Outer Dowsing Offshore Wind

The Applicant's Response to Procedural Decision and Change Notification dated 8 October

Date: October 2024
Document Reference: 17.1
Rev. 1.0

**Planning Act 2008 – Application for Development Consent
GT R4 Limited, trading as Outer Dowsing Offshore Wind (the “Applicant”)
The Proposed Outer Dowsing Offshore Wind Farm Order
Response to Procedural Decision and Change Notification
Application Reference: EN010130**

2.3 Revision to the Offshore Export Cable Corridor

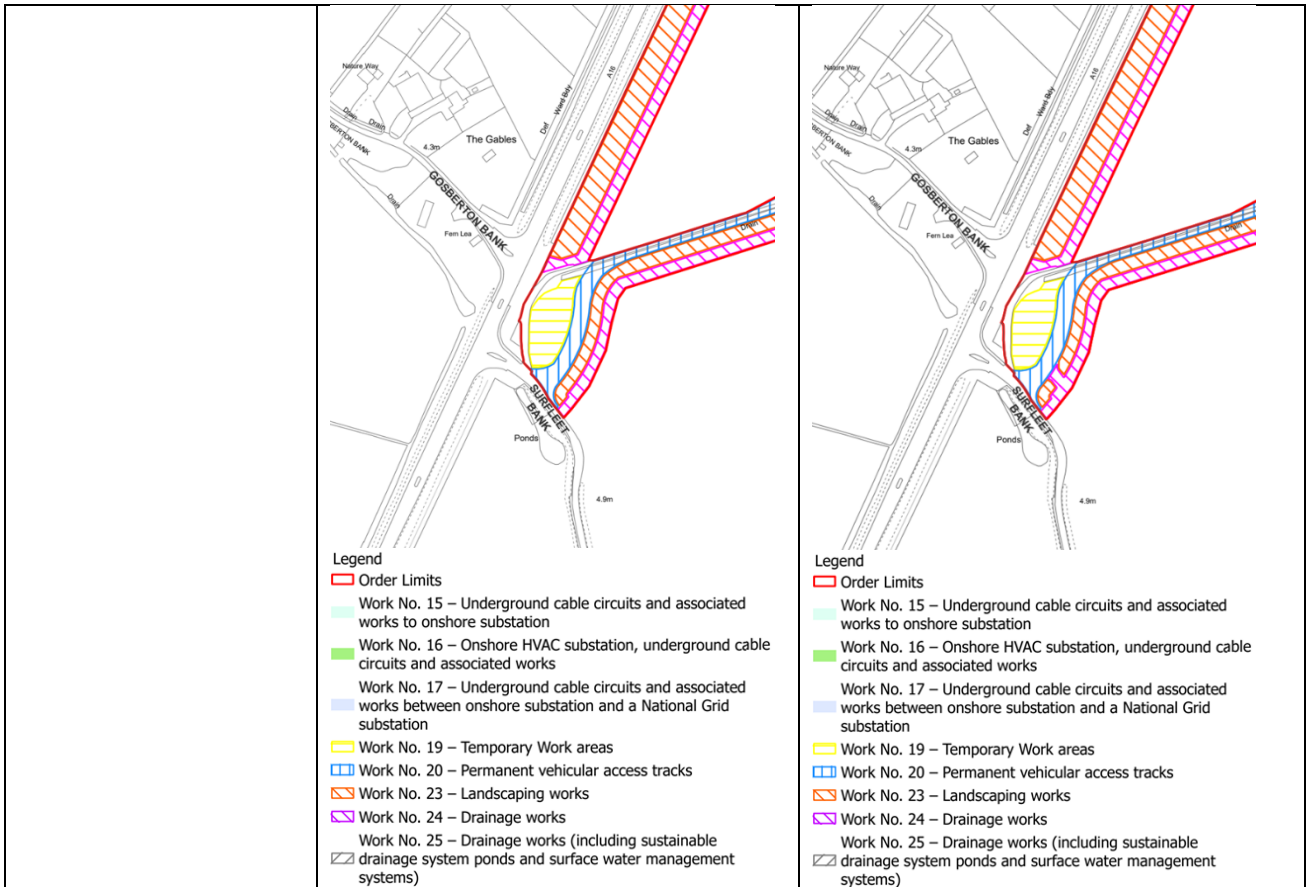
Information to include in a change notification	Applicant's Response
A clear description of the proposed change, including any new works, altered works and ancillary matters	<p>The northern section of the offshore Export Cable Corridor (ECC) within the inshore area has been removed from the Order Limits. In addition, a minor amendment has been made to the ORCP area within the southern route to exclude an area at the eastern extent.</p> <p>The total maximum offshore export cable lengths, number of cables, number of ORCPs and all other parameters remain, as provided within the DCO Application.</p>
A statement setting out the reasons and need for making the change to the application	<p>The offshore ECC presented within the Environmental Statement (ES) that supported the DCO Application included two routeing options within the inshore area of the cable route, a northern and a southern route. The northern route was included as it is situated north of the Inner Dowsing sandbank and thus avoided impacts to this designated feature. The southern route was also included as the northern route passes through aggregates Area 1805 which has an Exploration and Option area agreement with The Crown Estate, although this was due to expire on 31st August 2024. In the event that the option agreement was not taken up by the holder, this seabed area would have become available to the project, thus allowing the project to avoid crossing the Inner Dowsing sandbank.</p> <p>It has now been confirmed that the option on this area has been extended by TCE until 2025 (pers. comms. Hansons via email 1st May 2024), with a Marine Licence Application (MLA/2024/00227) having been made by the agreement holder on 25th April 2024 to permit aggregates extraction within the site for a period of 15 years. As such, it is clear that the agreement holder intends to take up the option over this area of the seabed for aggregate extraction, and therefore it is no longer a viable option for the project to pursue. Consequently, the project has excluded the northern route from the offshore ECC and is amending the Order Limits to exclude this section of the offshore ECC from the draft DCO.</p> <p>The minor amendment to the ORCP location within the southern route has been made as it would not be technically feasible to</p>

install the structures whilst meeting the minimum bend radii requirements for the offshore export cables.
A statement establishing whether the proposed change involves changes to the Order land	The proposed change involves a reduction to the Order land offshore. One of the options included within the application Order land for the offshore ECC and ORCPs has been removed from the Order land as a result of the proposed change. The change does not involve a request to include additional compulsory acquisition powers therefore the procedures in regulations 5 to 19 of the CA Regulations do not apply.
A statement establishing whether the proposed change to the application is expected to result in any new or different likely significant environmental effects	The environmental implications of this change have been reviewed to fully understand whether the changes affect the conclusions of the Environmental Statement (ES) and the Report to Inform Appropriate Assessment (RIAA). The assessment in relation to the conclusions of the ES is set out in the Environmental Report for the Offshore Restricted Build Area and Revision to the Offshore Export Cable Corridor (PD1-081). The assessment in relation to the conclusions of the RIAA is set out in the Habitats Regulations Assessment for the Offshore Restricted Build Area and Revision to the Offshore Export Cable Corridor (PD1-091). The conclusions of these reports are that the proposed change will have no effect on the overall conclusions drawn within ES or RIAA.

2.5 Onshore Order Limit amendments - change from landscaping works to drainage works

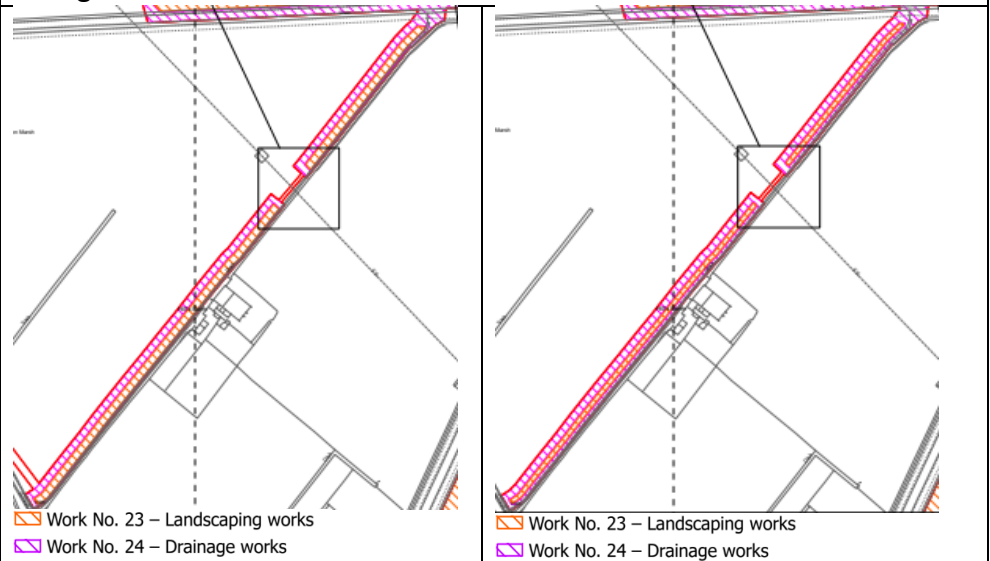
Information to include in a change notification	Applicant's Response
A clear description of the proposed change, including any new works, altered works and ancillary matters	The work number within a small area of the Order Limits around the access from the A16 to the OnSS has been amended to replace previously included screening planting (which included drainage rights) with drainage rights (Work No. 23 to Work No. 24) east of the A16 at Surfleet Bank. The plans below show an extract of this area on the Works Plans Onshore version 2 (AS1-004) on the left and on the Works Plans Onshore version 3 (PD1-004) on the right in order to demonstrate this change.

In addition, the width of the screen planting west of the A16 has been reduced from 10 metres to 6 metres, with the area which previously included screening planting now amended to drainage rights (Work No. 23 to Work No. 24). The plans below show an extract of this area on the Works Plans Onshore version 2 (AS1-004) on the left and on the Works Plans Onshore version 3 (PD1-004) on the right in order to demonstrate this change.
